RE: Comment Letter – Proposed Approval of an Amendment to the Water Quality Control Plan for the Los Angeles Region (Basin Plan) to Establish an Implementation Plan for the Malibu Creek Nutrients TMDL and the Malibu Creek and Lagoon TMDL for Sedimentation and Nutrients to Address Benthic Community Impairments

**Subject: COMMENT LETTER – IMPLEMENTATION PLAN FOR U.S. EPA MALIBU
NUTRIENT AND SEDIMENTATION TMDLS**

FIGURE 1
Upper Malibu Creek Watershed
Land Use Breakdown

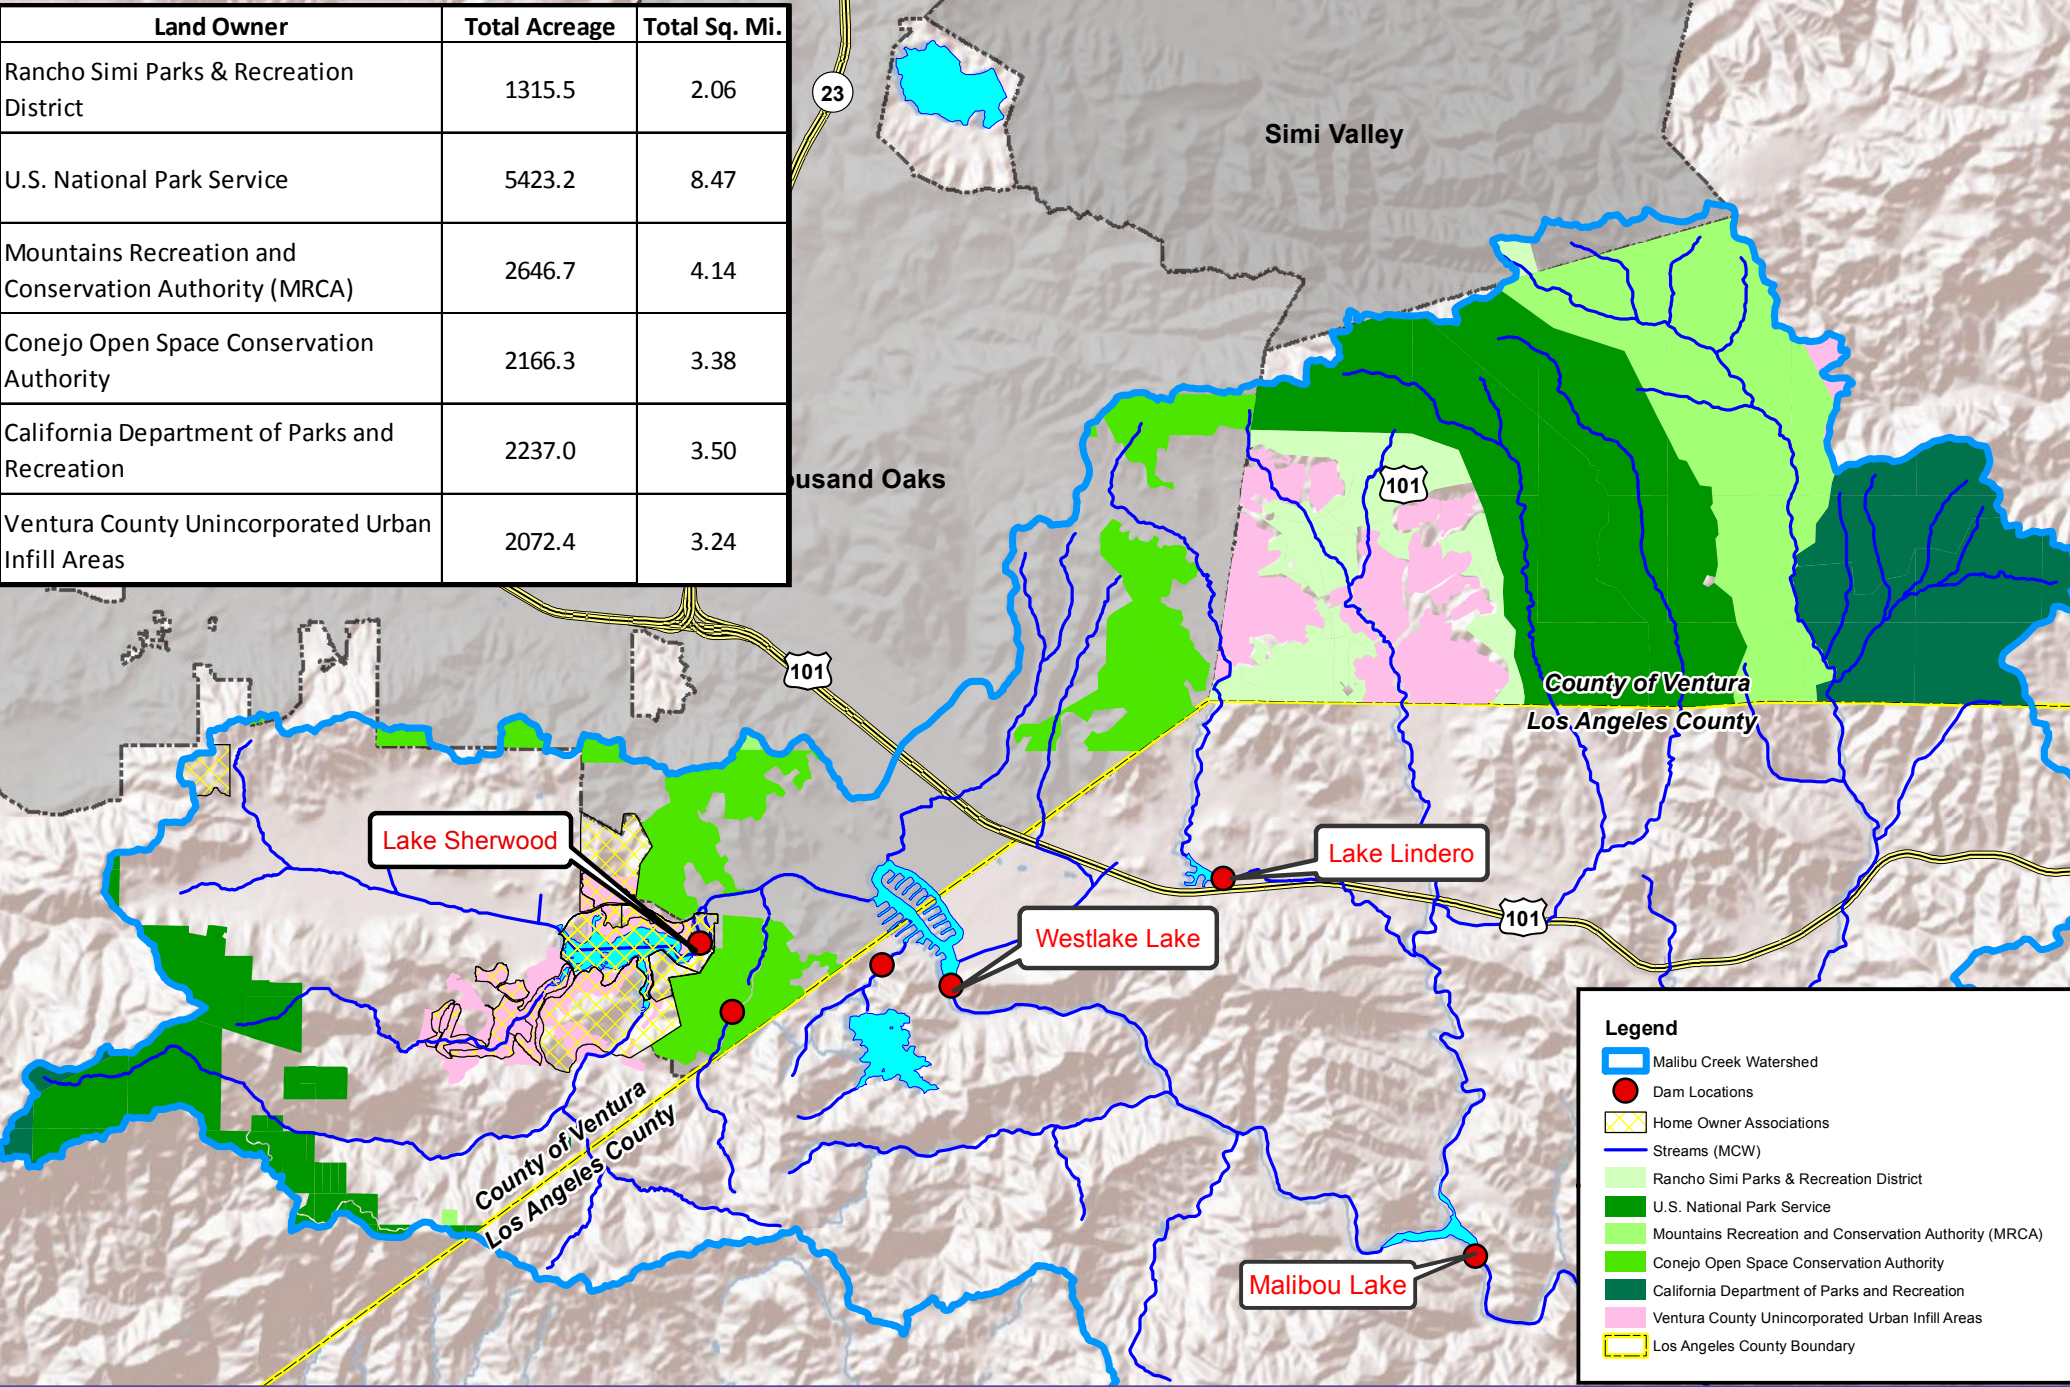
As proposed in the Proposed Amendment, the U.S. National Park Service and/or California Department Parks and Recreation were only listed under Cooperative Parties for Malibou Lake and Sherwood Lake, and to meet requirements for sedimentation below Malibou Lake (outside upper MCW). The Proposed Amendment does not require the U.S. National Park Service and California Department Parks and Recreation to address nutrients and conduct monitoring required for MS4s. Other primary property owners of undeveloped lands such as Rancho Simi Parks & Recreation District, Mountains Recreation and Conservation Authority, and Conejo Open Space Conservation Authority are not listed in the Proposed Amendment.

Request: Include the Rancho Simi Parks & Recreation District, U.S. National Park Service, Mountains Recreation and Conservation Authority, Conejo Open Space Conservation Authority, and California Department of Parks and Recreation as responsible parties in the Proposed Amendment for monitoring and implementation plan development efforts within their jurisdictional areas at the comparable requirement levels as MS4s and other TMDL Responsible Parties.
